**LETTER TO INDUSTRY**  
**LTI #. 00000005**

**DCSM REFERENCE:** Article 6  
Detail FS-1.1

**SUMMARY OF  
ISSUE/TOPIC:** Leak Testing

CITY OF MANASSAS, VIRGINIA  
 DEPARTMENT OF PUBLIC WORKS

**FIRE HYDRANT SETTING**

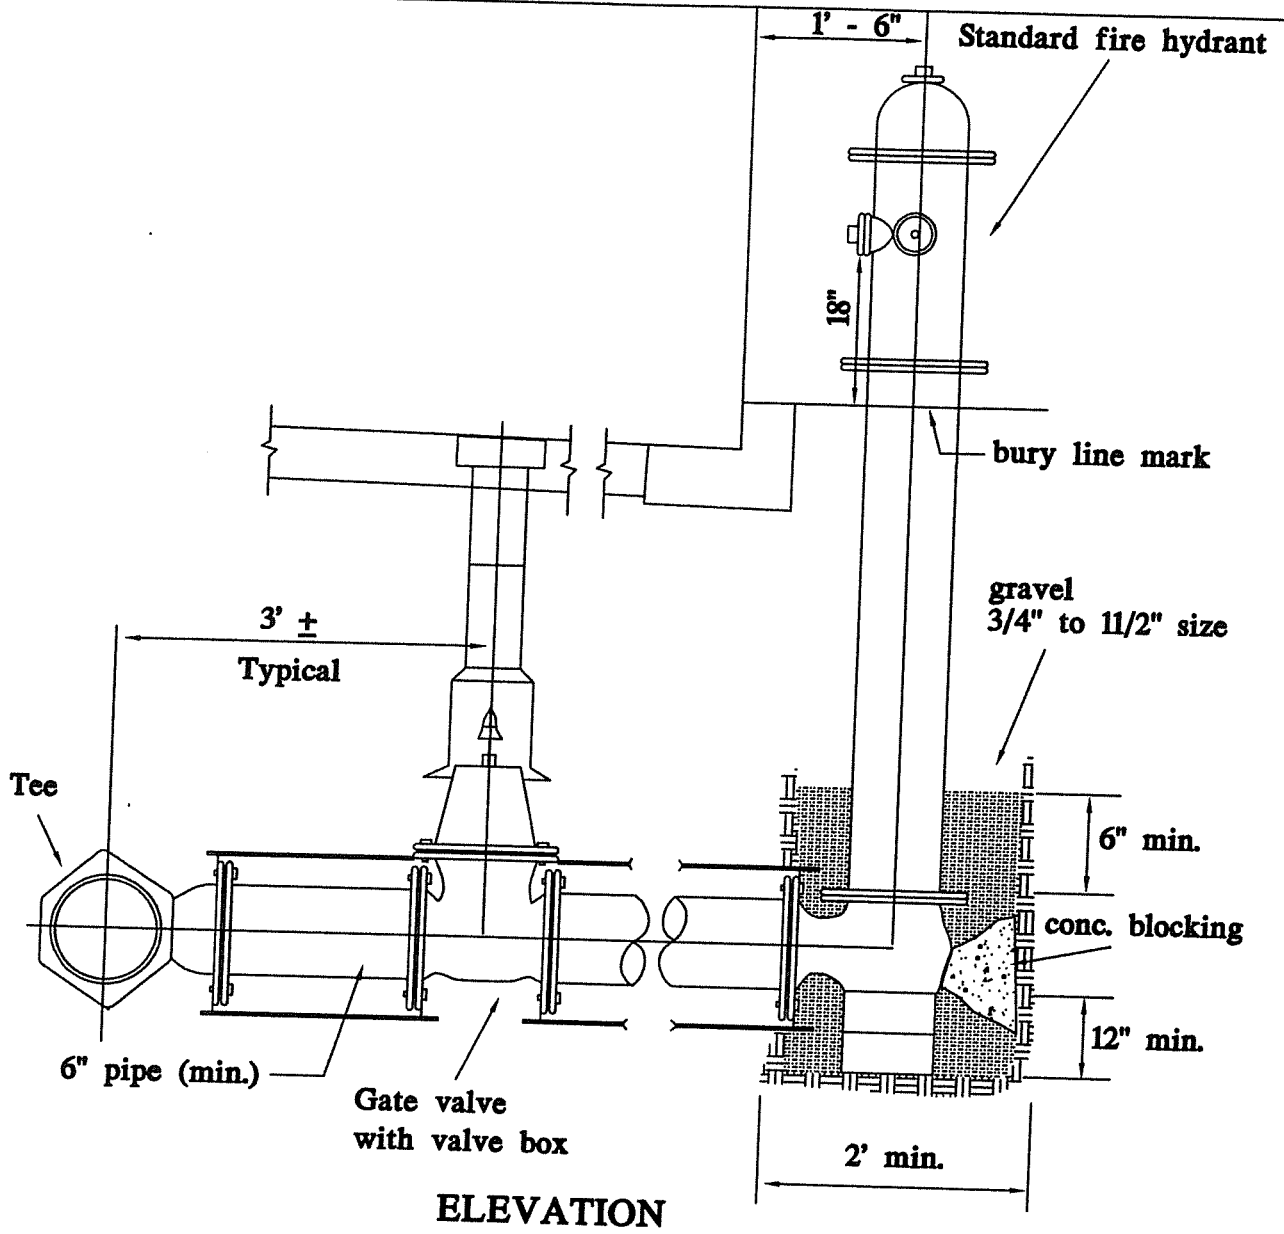
**POLICY /  
REQUIREMENTS /  
GUIDELINE:** Replace existing Detail FS-1.1 with the attached detail FS-1.1

**BACKGROUND:** The Virginia Department of Health (VDH) requires that the following note be added to Detail FS-1.1:

5. "Hydrants with weep holes should not be allowed in areas subject to high groundwater, to flooding, to contaminant or pollutant spills, or in areas where surface water ponds. If there is no alternative location to avoid the above hazards, then the weephole can be piped to daylight with the pipe end screened."
